LEXINGTON-FAYETTE URBAN COUNTY GOVERNMENT CONTRACT CHANGE ORDER Page 1 of 2	Date:	May 29, 2015	
	Project:	Stone Arch Repair	
	Location:	Dunbar Community Ctr	
To (Contractor): ABC Construction	Contract No.	97-2015	
	Original Contract Amt.	\$39,400.00	
	Cumulative Amount of Previous Change Orders	\$0.00	
	Percent Change - Previous Change Orders		0.00%
	Total Contract Amount Prior to this Change Order	\$39,400.00	
	Change Order No.	1

PROJECT: Stone Arch Repair

DUNBAR STONE ARCH REPAIR

Re: Request for Change Order #1 at Dunbar Community Center
Purchase Order #LF00124588

Sheet Number: **S-1**
 Project Number: 19-008

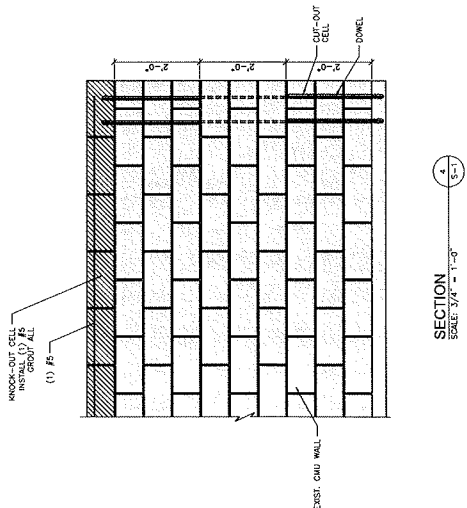
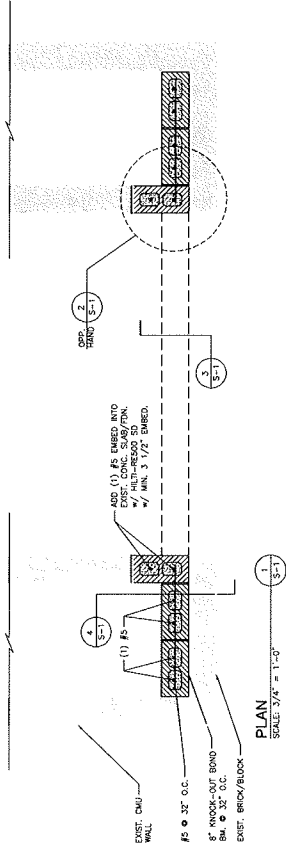
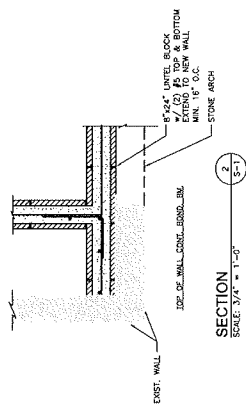
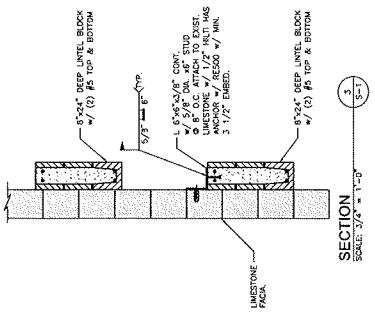
This change order is being submitted to correct concealed conditions discovered at the Dunbar Stone Archway Renovation. All work in this change order is based on the original plans and specifications of Fitzsimmons Office of Architecture and the drawings submitted by Pyramid Consulting Structural / Civil Engineers Sheet S-1.

This Change Order will be for installing two new footers at the inside base of the wall, building a new wall from these footers close to the full height of the wall. It will also raise the two existing block walls upward near the roof of the structure. These walls will be reinforced with concrete and steel as specified. A new angle iron will be installed behind and above the stone arch with epoxy anchors tying the new wall and stone together. This work will require the existing ceiling to be removed and replaced.

General view during construction. 5/8/15

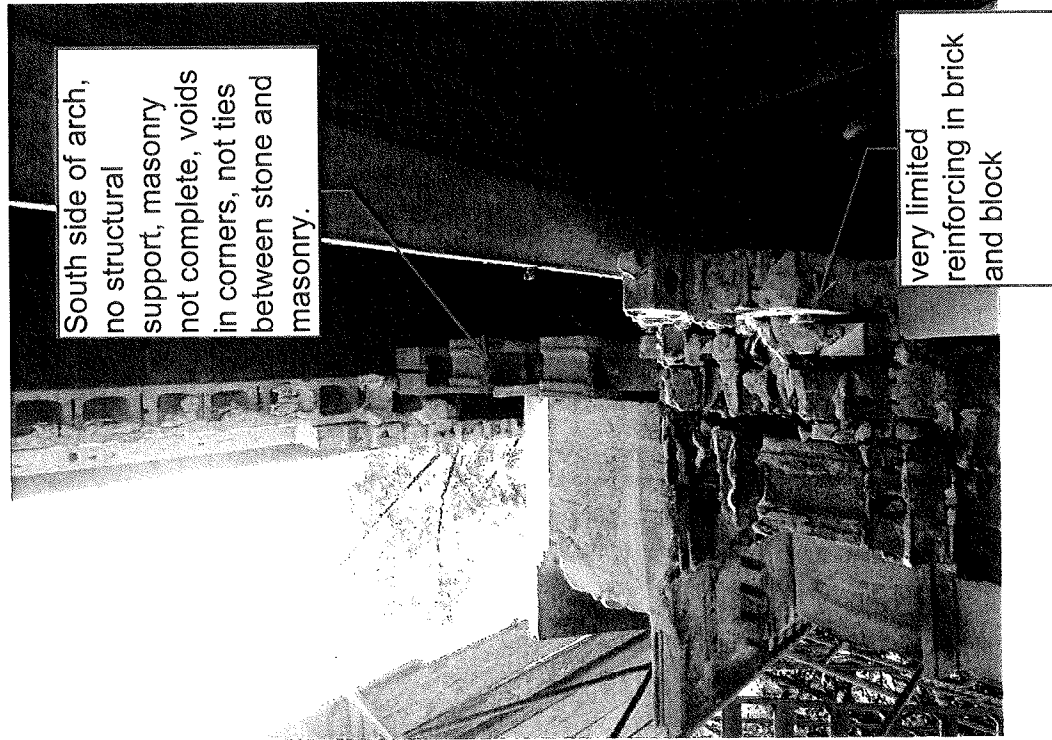
South side of arch, no structural support, masonry not complete, voids in corners, not ties between stone and masonry.

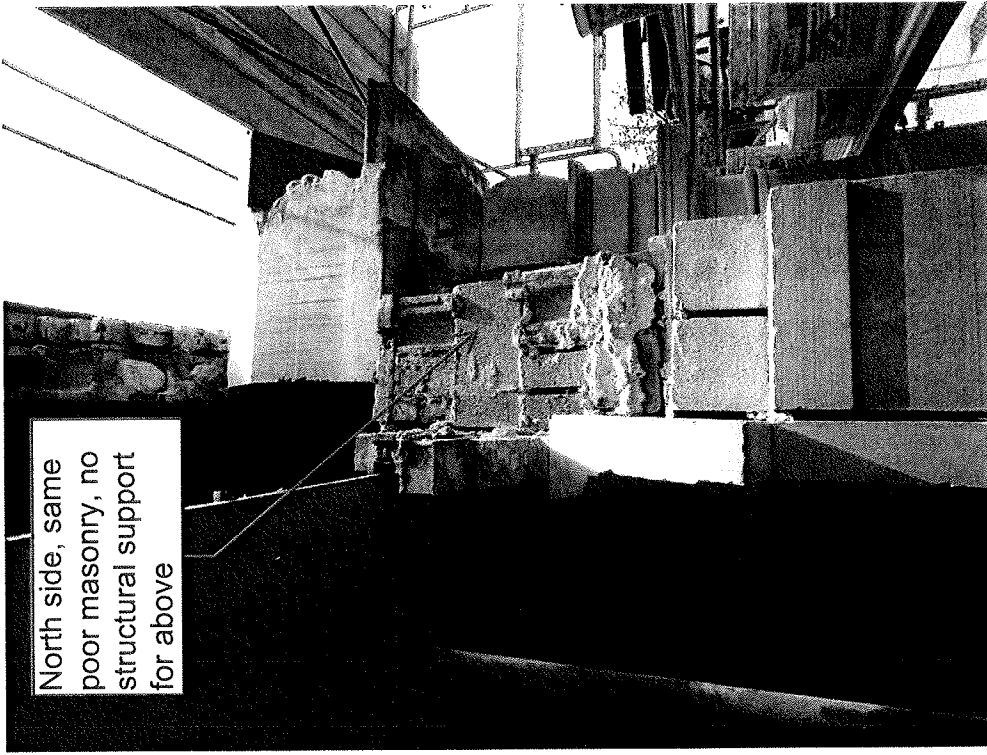
very limited reinforcing in brick and block

North side, same poor masonry, no structural support for above

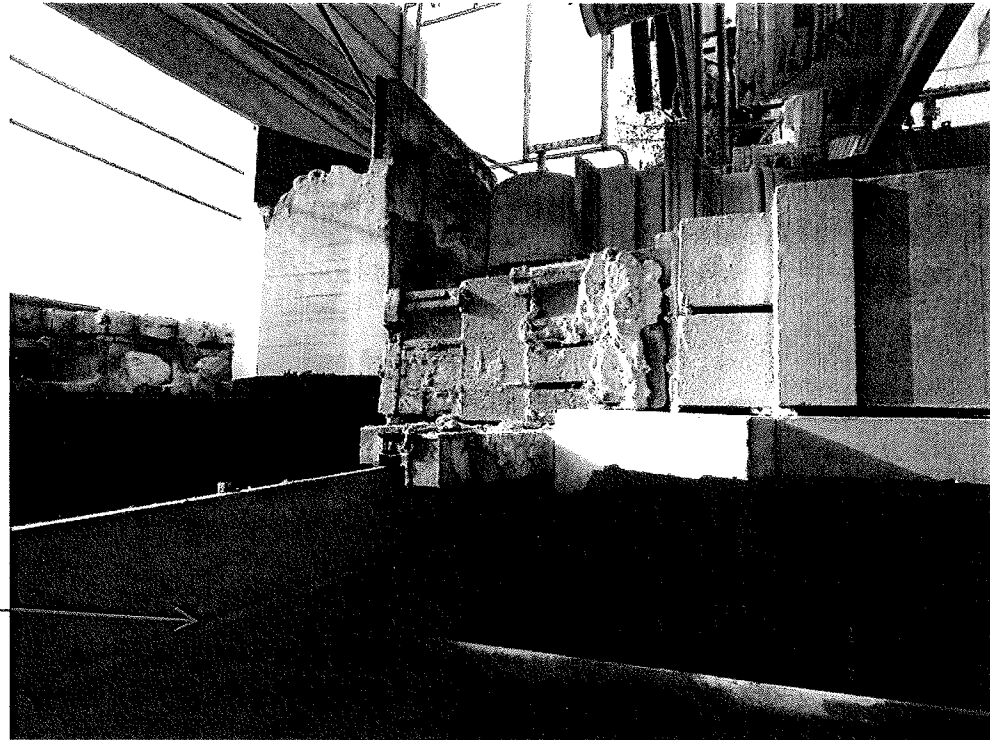
plaster ceiling
suspended from
above

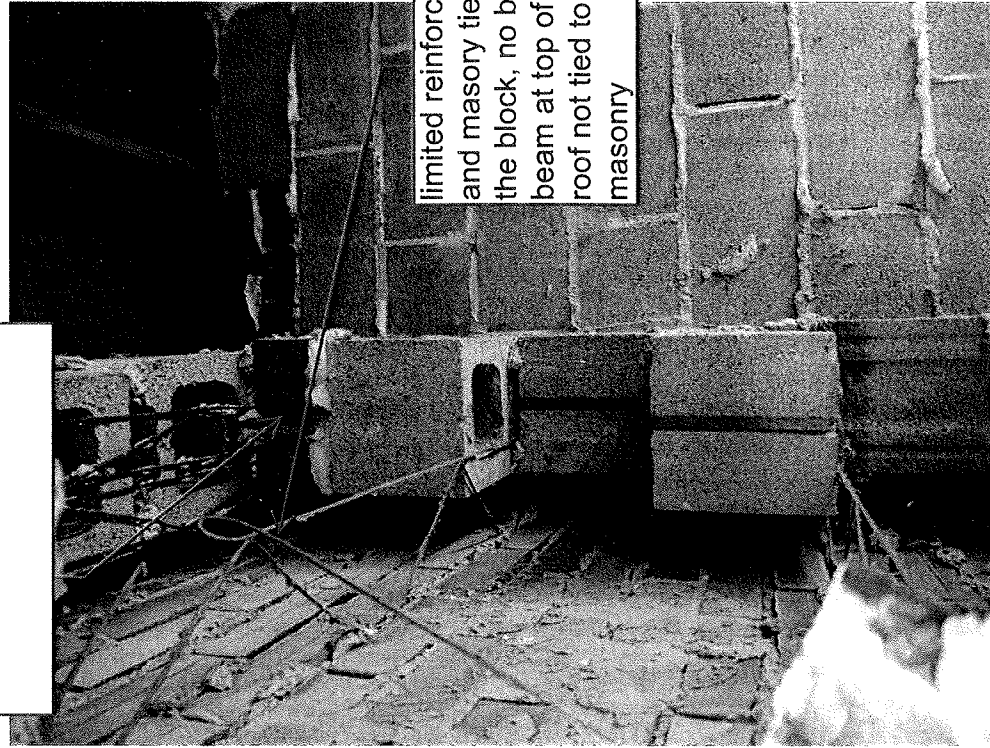
poor quality masonry infill,
not complete backup wall,
voids in the block

limited reinforcing
and masonry ties to
the block, no bond
beam at top of wall,
roof not tied to
masonry
